SERVICE BULLETIN

SB No. 001

Issue No. 1 Aircraft Type T67A

Aileron Control Circuit Inspection

FIG 1

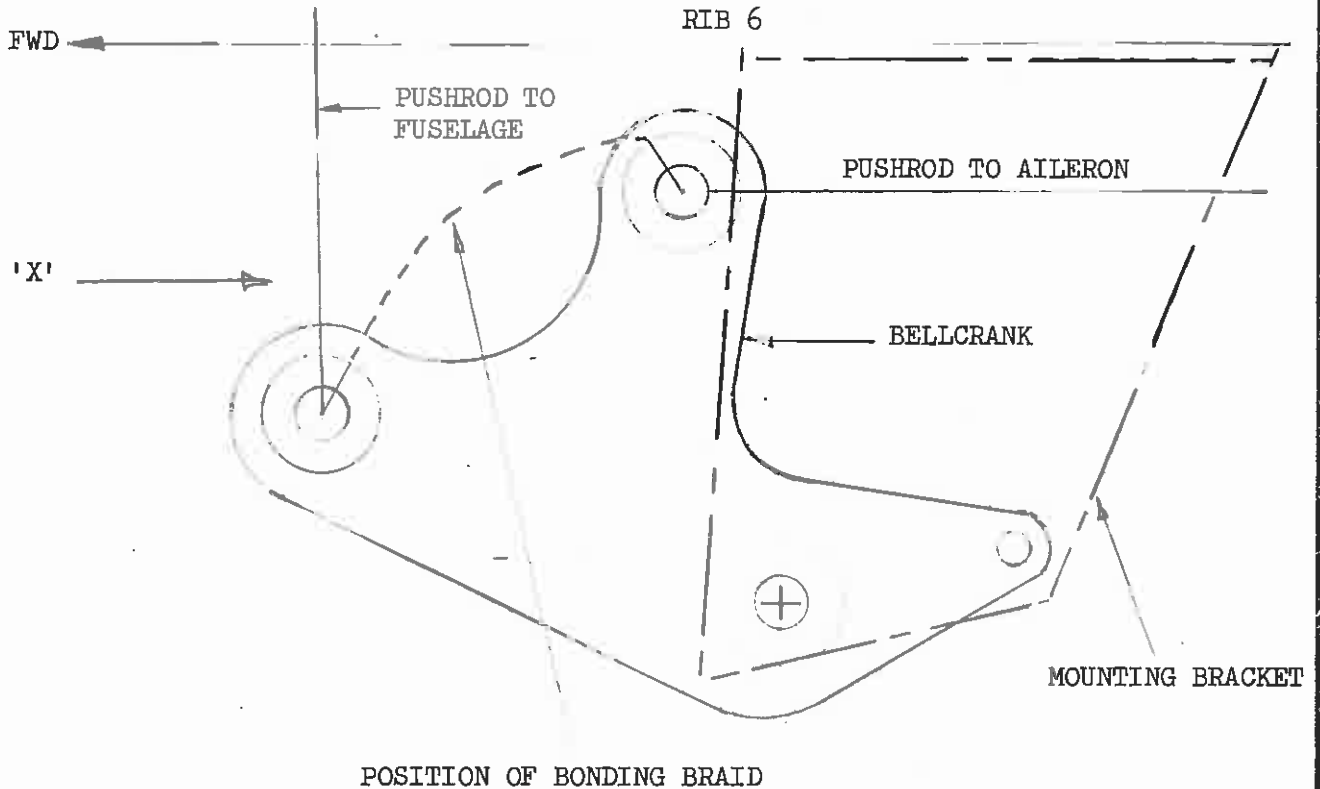
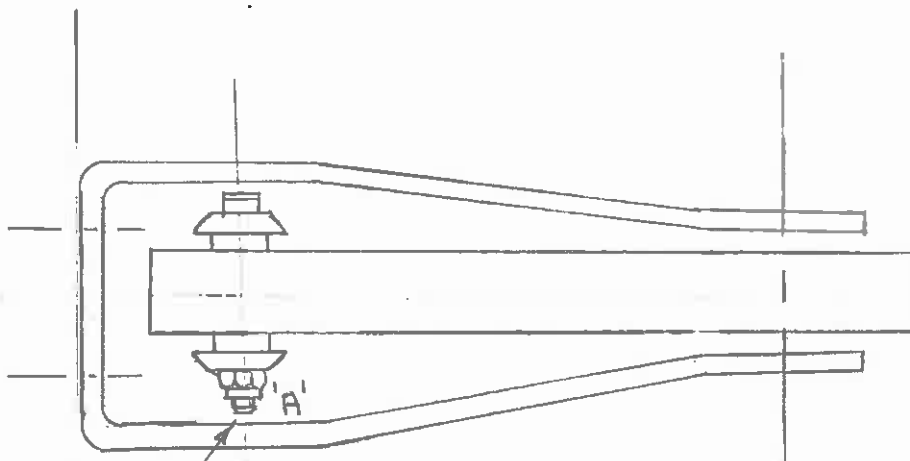
Remove the outboard inspection cover from each wing. Check the clearance between the bolt tail and the bellcrank mounting bracket in area 'A' of Fig.1 is at least 1.5mm (0.060"). If the clearance is less than this the bolt tail must be shortened.

Ensure that the bolt is still in safety by at least 2 thread pitches 1.6mm (0.063").

When replacing the nut ensure the bonding braid is re-positioned as shown in Fig.1
